**Brighton
Council**

Your Ref: DA 2025/095
Our Ref: 25.133

PLANNING APPLICATION DA 2025/00095 – RESPONSE TO REQUEST FOR ADDITIONAL INFORMATION

PROJECT: CONCRETE BATCHING PLANT
AT: 1 / 13 CROOKED BILLET DRIVE
BRIDGEWATER
FOR: HAZELL BROS GROUP PTY LTD

DIMENSIONS ARE IN MILLIMETRES. DO NOT SCALE. CHECK AND VERIFY ALL DIMENSIONS ON SITE. REFER DISCREPANCIES TO THE SUPERINTENDENT. ALL WORK SHALL BE CARRIED OUT IN ACCORDANCE WITH BUILDING CODE OF AUSTRALIA, APPLICABLE AUSTRALIAN STANDARDS & LOCAL AUTHORITY REQUIREMENTS.

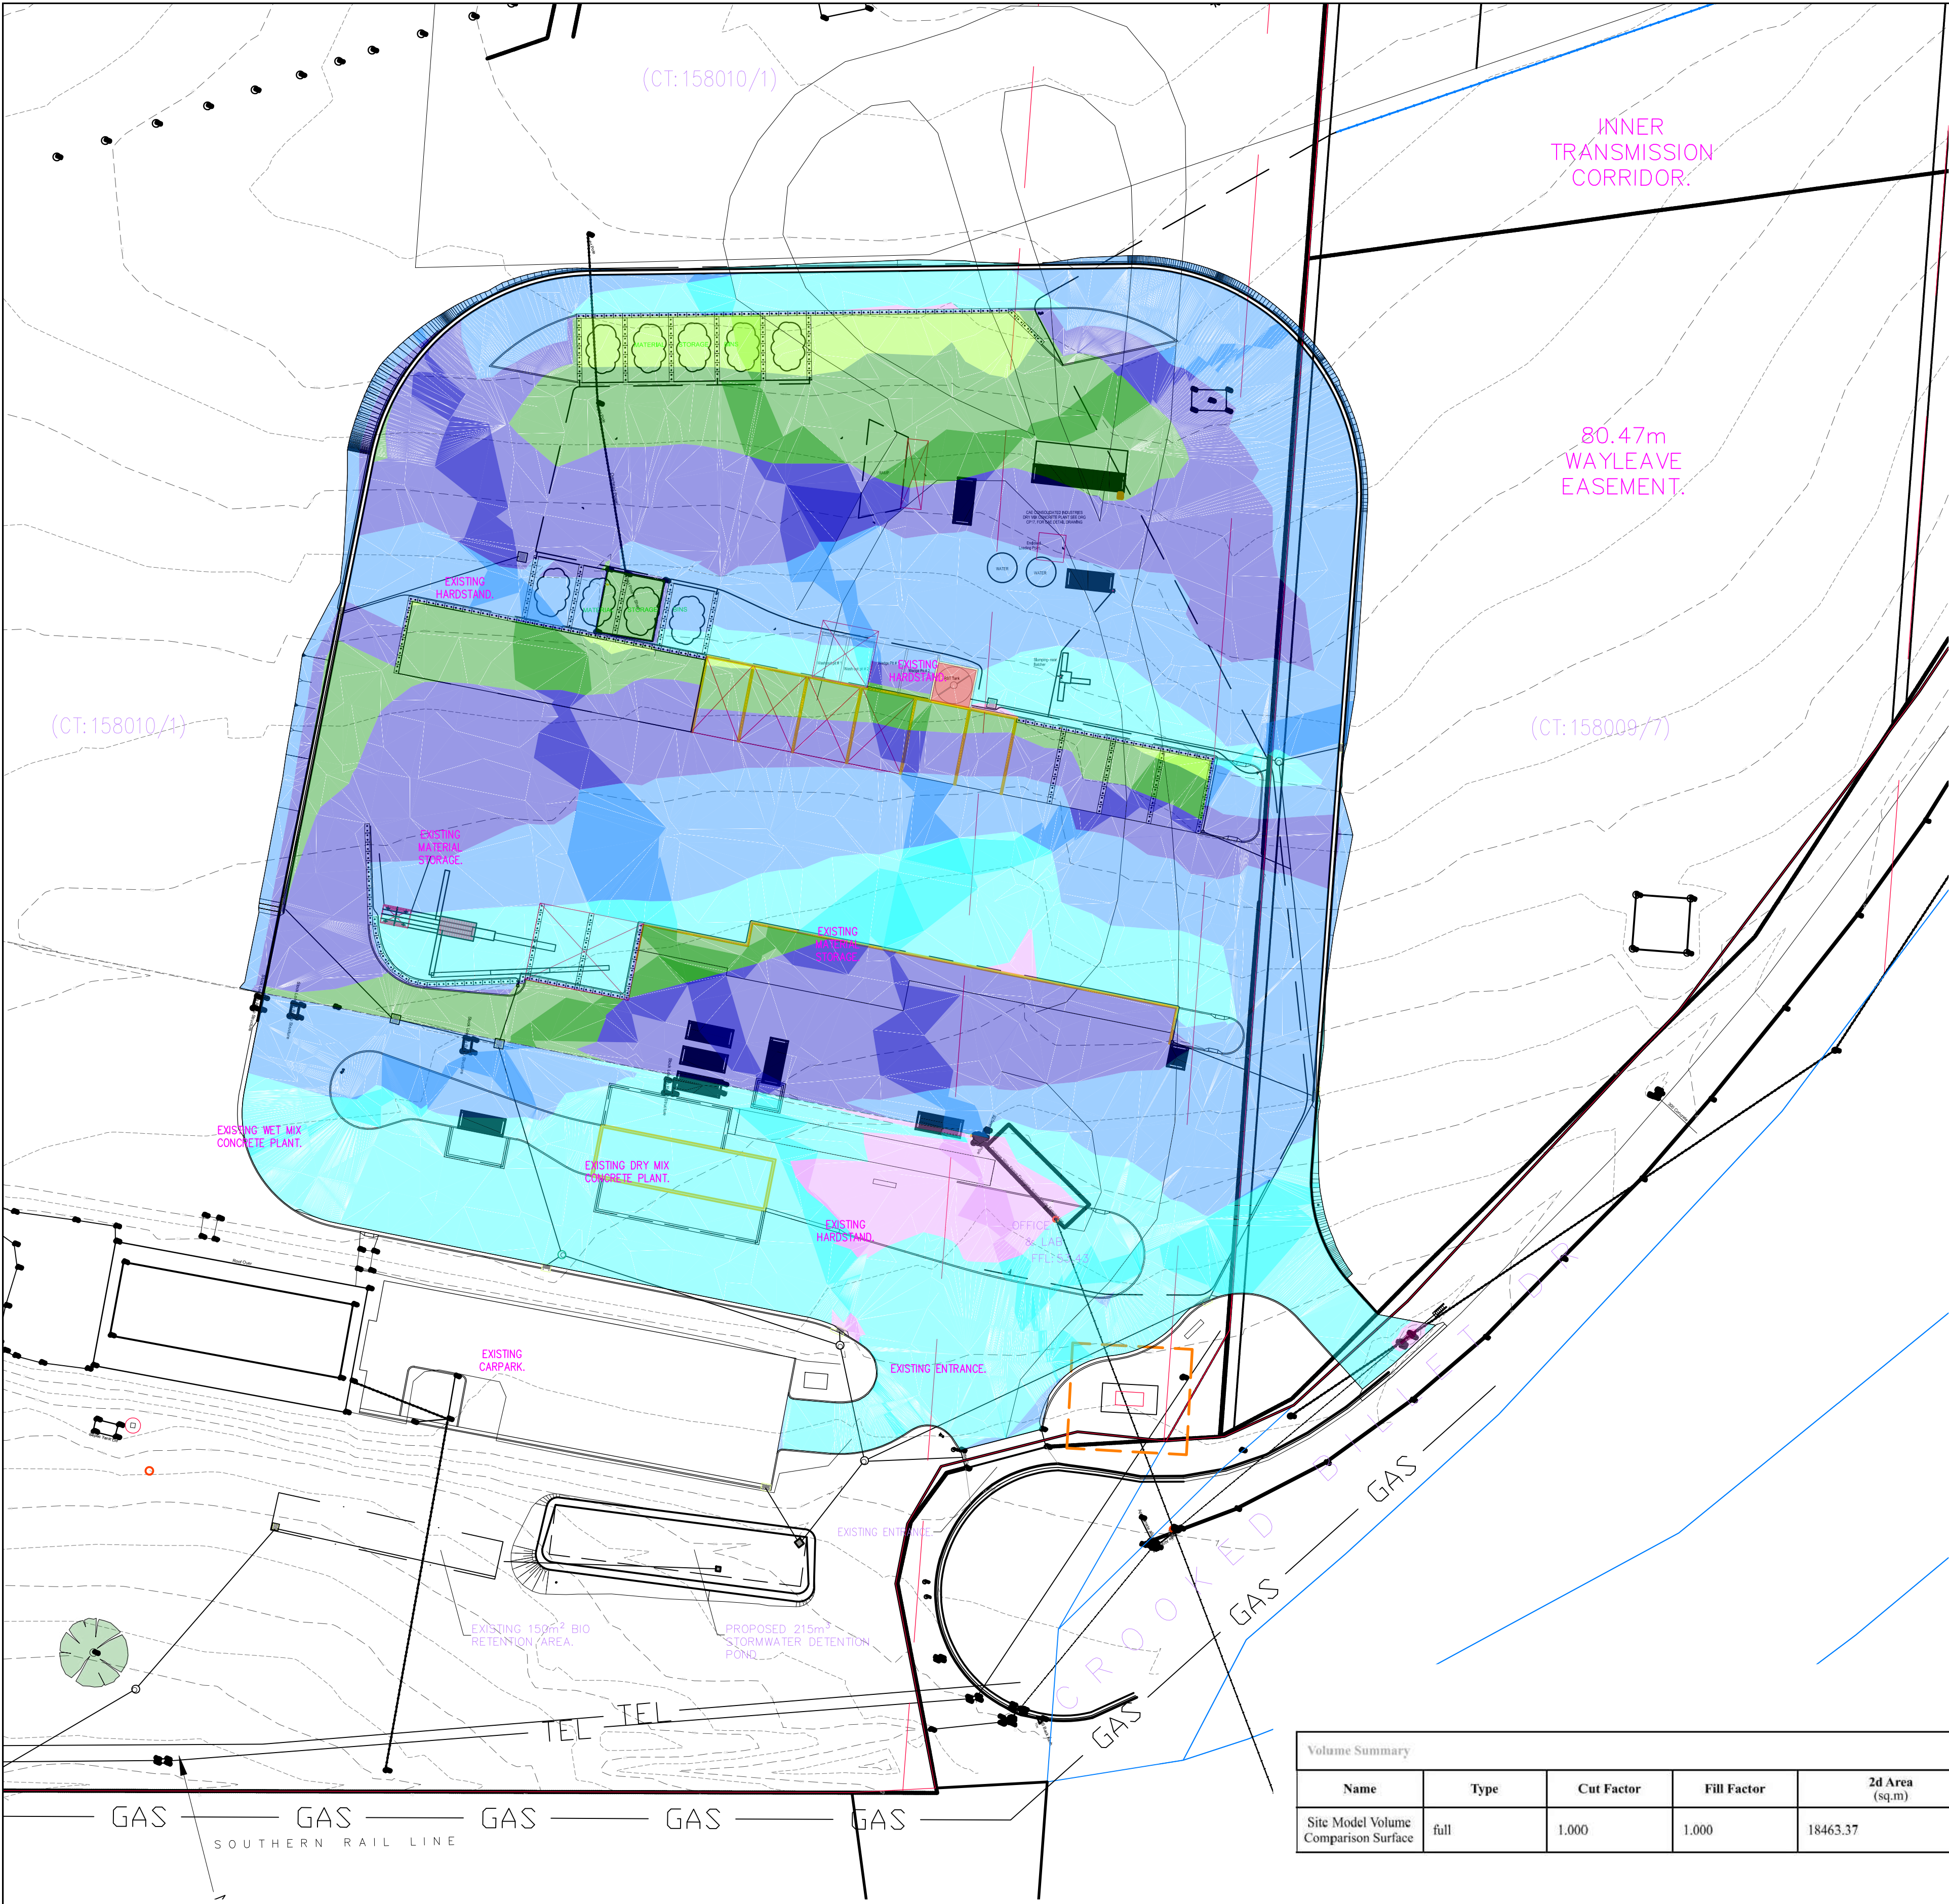
- The following relevant documents accompany this response:
 - Sample Turn Paths Sheet 2, Prepared by 6ty°, Drawing No. CP19, Revision A, Dated 25 July 2025; and
 - Amended Traffic Impact Statement (TIS), Prepared by Traffic & Civil Services, dated 1 August 2025.

The amended plan shows a bicycle parking space as required by the acceptable solution for the relevant code standard. The amended TIS references the location of this parking space.

- The amended Sample Turn Paths Sheet 2 considers the circulation of vehicles associated with the existing dwelling through the site, and this is reflected in the amended TIS.
